**CITY PLANNING COMMISSION**  
 1231 "I" STREET, SUITE 200, SACRAMENTO, CA 95814

- APPLICATION:**
- A. Negative Declaration
  - B. Lot Line Adjustment to merge two undeveloped parcels
  - C. Plan Review for a six unit apartment complex on 0.3+ acres in the Multi-Family Review [R-3R(EA-4)] zone

**LOCATION:** 2601 47th Avenue

**Site Plan**  
**Ventura Garden Apartments**  
 Sacramento, Ca.

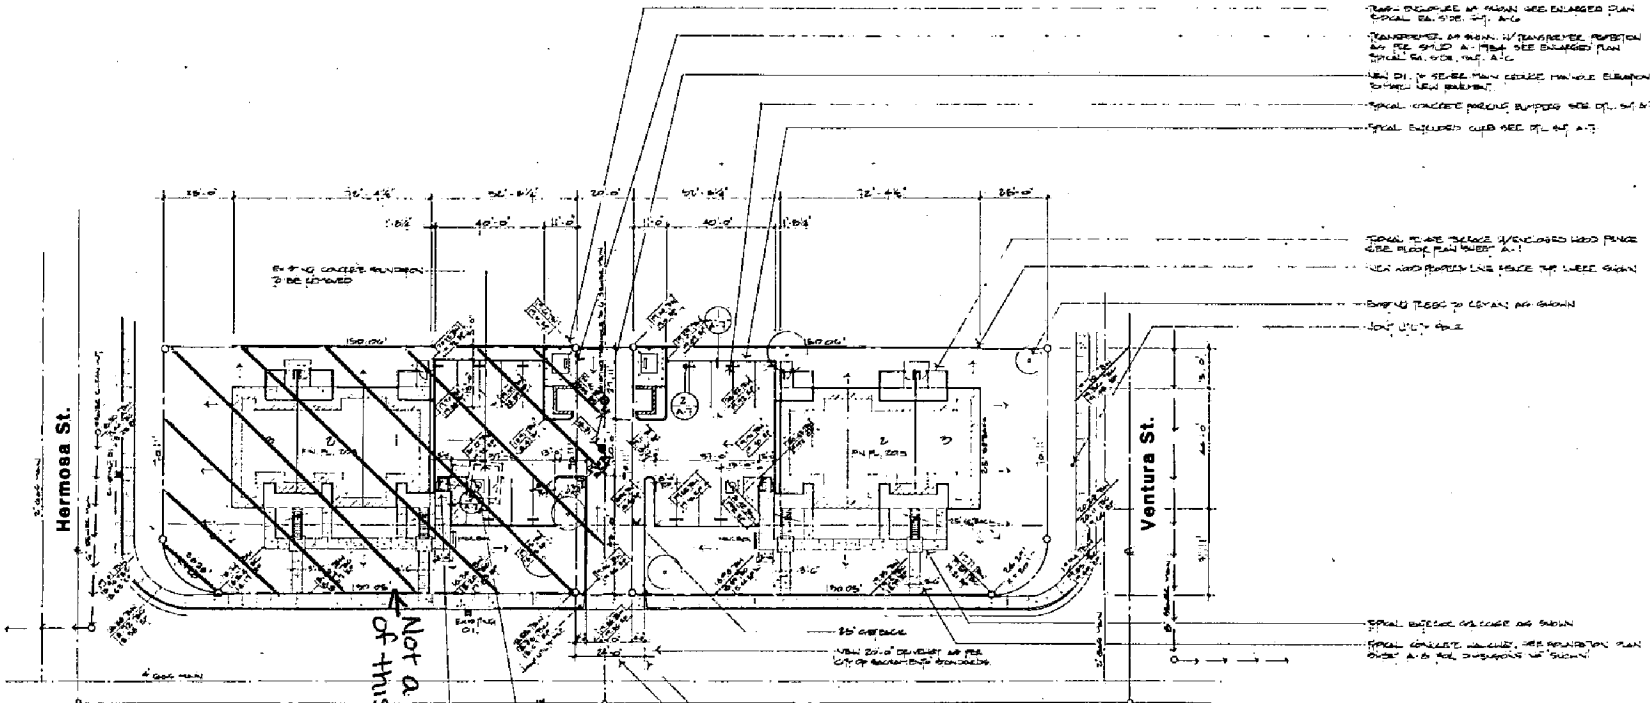
2. The portion of the sidewalk which extends from the apartments toward the public right-of-way of 47th Avenue should be removed to minimize on-street parking.

The six unit apartment complex requires nine parking spaces. The applicant proposes nine spaces located with access from the alley. The parking lot and alley shall be paved to City standards. The alley shall line up with the existing alley and not be offset as shown on proposed site plan.

1. The parking stall directly adjacent to the wall of the building shall be an oversized compact stall in order to allow easier maneuverability.
2. The parking lot should be screened from view from 47th Avenue by a low stucco wall. The wall should look similar to the building and be located directly adjacent to the parking area. There should also be landscaping in front of this wall.
3. The applicant shall also provide a 6 foot solid masonry wall along the property line between the parking area and the adjacent single family residential lot.

The trash enclosure is located with its access off the alley. There needs to be an opening for pedestrian access from the interior of the site and the access gates should not face the alley. The trash enclosure shall be built to the requirements of the Zoning Ordinance.

7. The parking lot and alley shall be paved to City standards.
8. The alley shall line up with the existing right-of-way. The full right-of-way shall be improved, with no obstructions, to the satisfaction of the Public Works Department.

9. The parking lot shall be screened from view by a low stucco wall similar to the building.
10. The applicant shall provide a 6 foot masonry wall along the property line between the parking area and the adjacent single family lot.

13. A detailed landscape plan shall be submitted to the Planning Director for review and approval prior to issuance of building permit.
14. The trash enclosure shall have an opening for pedestrian access and be built to the requirements of the Zoning Ordinance. Access gates shall not open into the alley.

<b>A-3</b>	<p><b>Front &amp; Rear Elevations</b>  <b>Ventura Garden Apartments</b>          Sacramento, Ca.</p>	<p><b>DONALD JOSEPH CO</b>          Architect</p>
------------	--	---

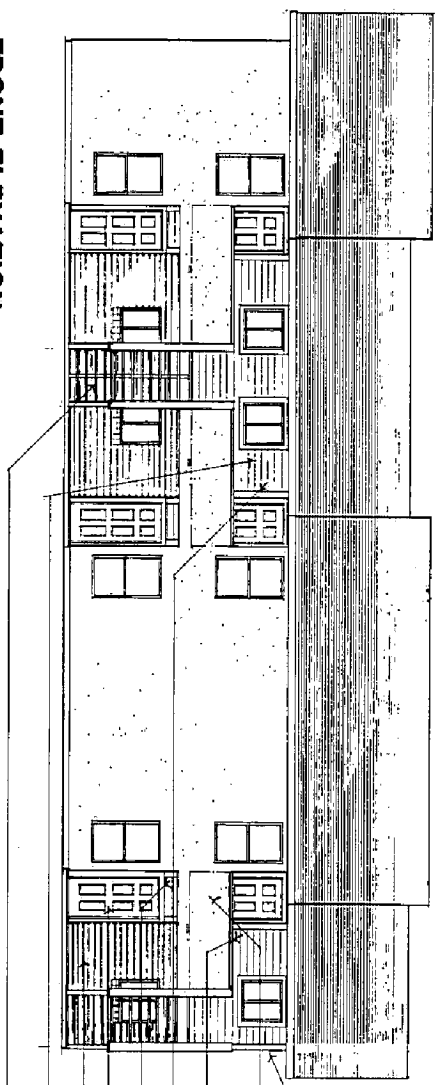
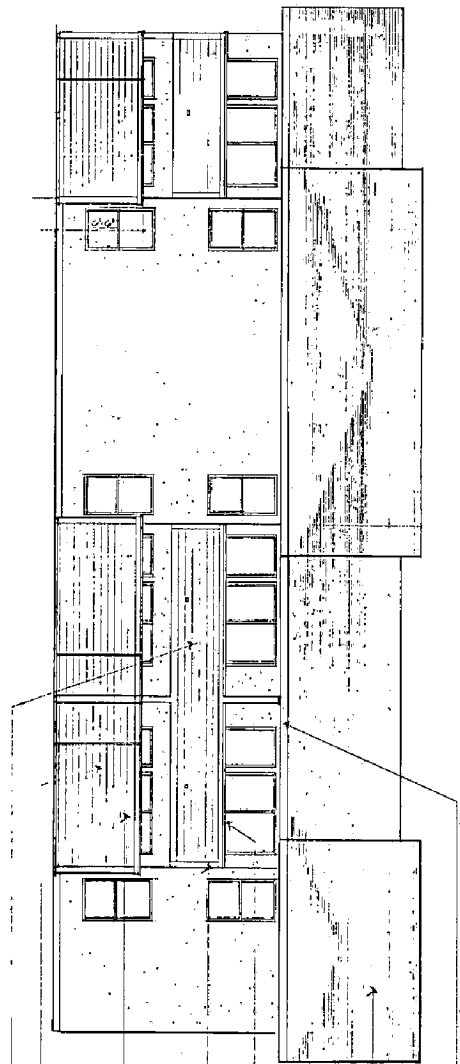
1. The applicant should reverse the building orientation so that the side of unit number 1 is facing Ventura Street and unit 3 is near the parking area. This is to better allow the enhancement of the elevation facing Ventura Street. This enhancement can be achieved by wrapping the second story balconies around facing Ventura Street. Staff also suggests a window be placed on the wall facing the balcony. These balconies can project 2 feet into the front yard setback without requiring a variance.

4. The windows should be trimmed using the standard window trim treatment as shown in Exhibit C.
5. The applicant should provide a raised planter or large shrubs along the stucco walls facing 47th Avenue in order to break up the bare wall.

1. The building orientation shall be reversed so Unit 1 is facing Ventura Street and Unit 3 is near the parking area.
2. The second story balconies shall wrap around the building to the Ventura Street side.
3. The portion of the sidewalk extending from the apartments toward the public right-of-way of 47th Avenue shall be removed.
4. The stairs shall be redesigned so the toe of the stairways points toward the parking lot.

5. The windows shall be trimmed using the standard window trim treatment per Exhibit C.
6. The applicant shall provide a raised planter or large shrubs along the stucco walls facing 47th Avenue.
